STAFF REPORT: JULY 14, 2021 MEETING

APPLICATION NUMBER: 21-7360

ADDRESS: 1321 LABROSSE

SCOPE: WINDOWS REPLACED WITHOUT APPROVAL

West Side Elevation

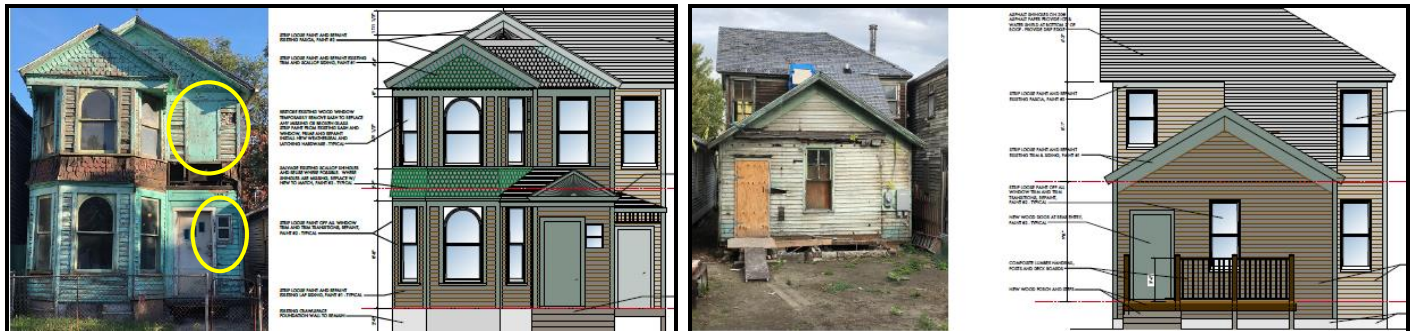
- Removal of one historic, wood double-hung window on the second story, and installation of one double-hung, one-over-one vinyl sash (clear glass), color: white.

Applicant’s 2021 Floor Plan – “Scheme G”

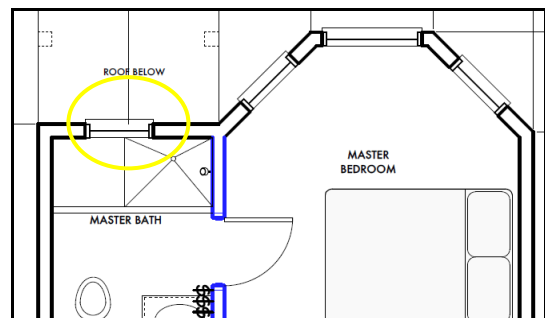
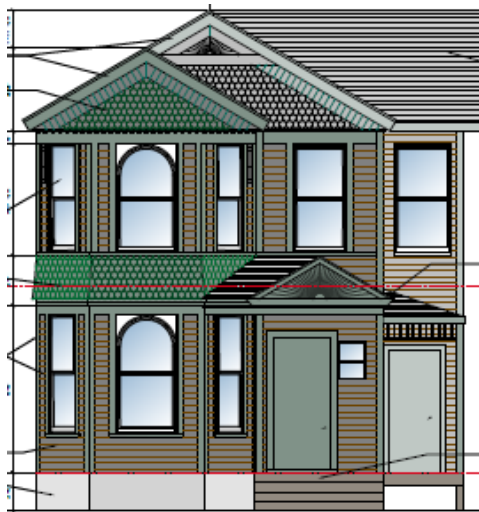
- The second story floor plan (“Scheme G” – included with the applicant’s submission materials) shows the front elevation second story window gone, in contrast with the floor plan submitted as part of the 2019 rehabilitation application.

Applicant Rendering

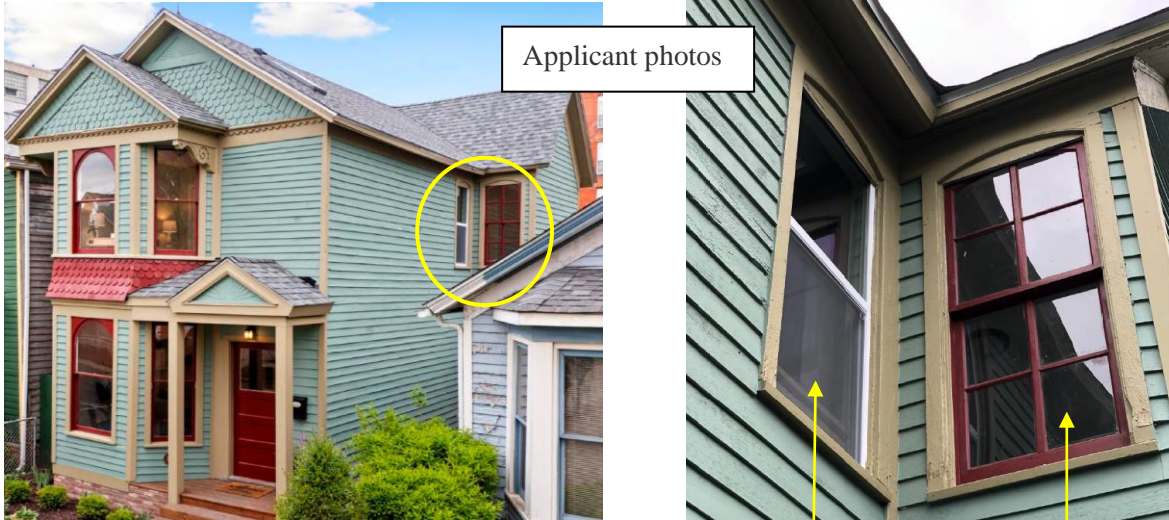
- The façade of this house offers a multitude of patterns and angles, in line with the Queen Anne architectural style. The window opening above the front porch (as shown in the below-left rendering) completed the horizontal line (or rhythm) of windows at the second story, as well as creating a vertical balance with the first story openings. The removal of this window opening created a flat void within this highly detailed façade.
